<b>Docket Number:</b>	15-AFC-02
<b>Project Title:</b>	Mission Rock Energy Center
<b>TN #:</b>	213760
<b>Document Title:</b>	Mission Rock Energy Center - Proposed Revisions to Cultural Resources Data Requests
<b>Description:</b>	N/A
<b>Filer:</b>	Mike Monasmith
<b>Organization:</b>	California Energy Commission
<b>Submitter Role:</b>	Commission Staff
<b>Submission Date:</b>	9/21/2016 6:33:24 PM
<b>Docketed Date:</b>	9/22/2016

**RE: MISSION ROCK ENERGY CENTER (15-AFC-02) PROPOSED REVISIONS TO CULTURAL RESOURCES DATA REQUESTS**

## **MISSION ROCK ENERGY CENTER (15-AFC-02) PROPOSED REVISIONS TO CULTURAL RESOURCES DATA REQUESTS**

Property Owners Within Architectural Survey Area  
Mission Rock Energy Center  
(15-AFC-02)

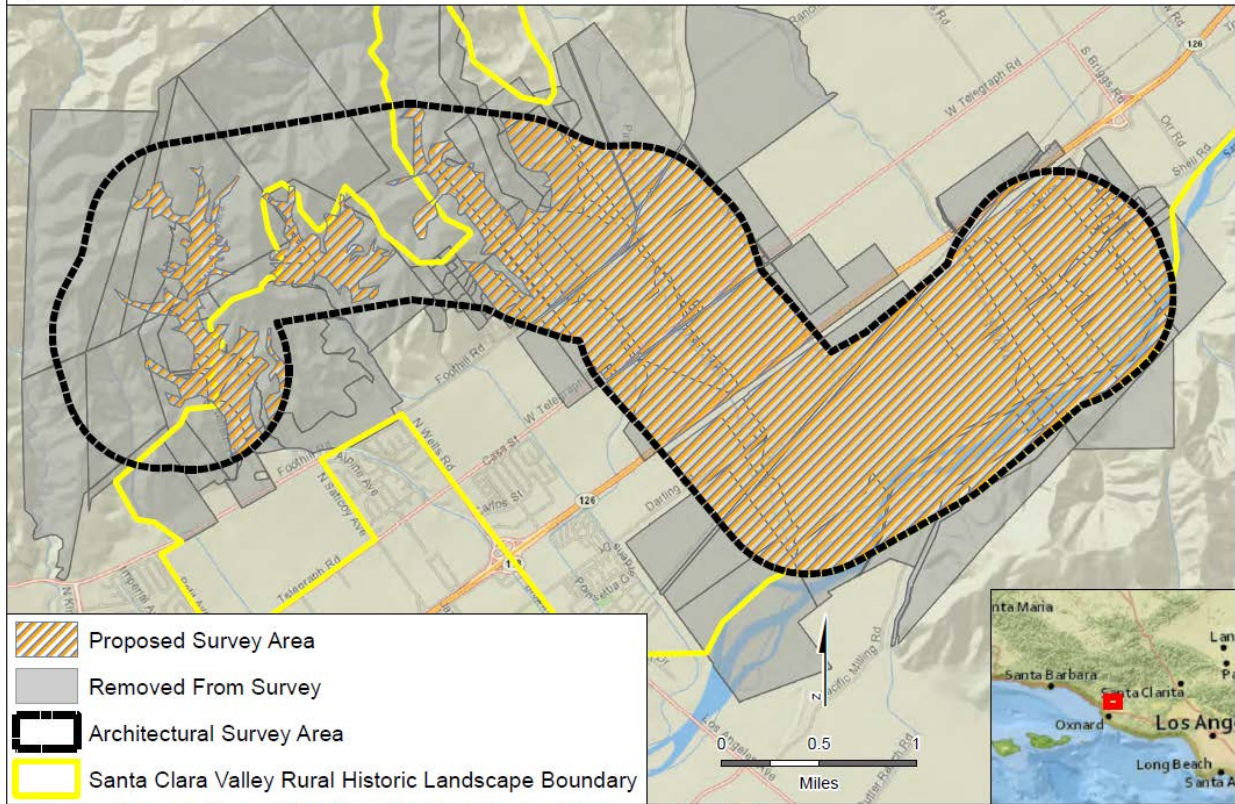
Given the applicant's unwillingness to complete the built-environment windshield survey as described in Appendix B, staff has made a good faith effort to apply a set of criteria which would reduce the survey area while still capturing the majority of cultural resources in the PAA. These criteria include:

- Remove parcels included in the survey area, which only slightly overlap with the PAA;
- Remove portions of parcels outside the PAA;
- Reduce the survey area by eliminating land with a slope unlikely to contain cultural resources that contribute to the historic landscape;
- Reduce the survey area by eliminating parcels with development not consistent (less than 45 years of age) with the built environment resources that contribute to the historic landscape.

However, if cultural resources are identified outside of the reduced survey area, staff reserves the right to analyze impacts to these resources at a later date and as part of its independent analysis. The following map represents the remaining survey area after applying the above criteria.

This approach would reduce the survey area within the PAA by 33 percent.
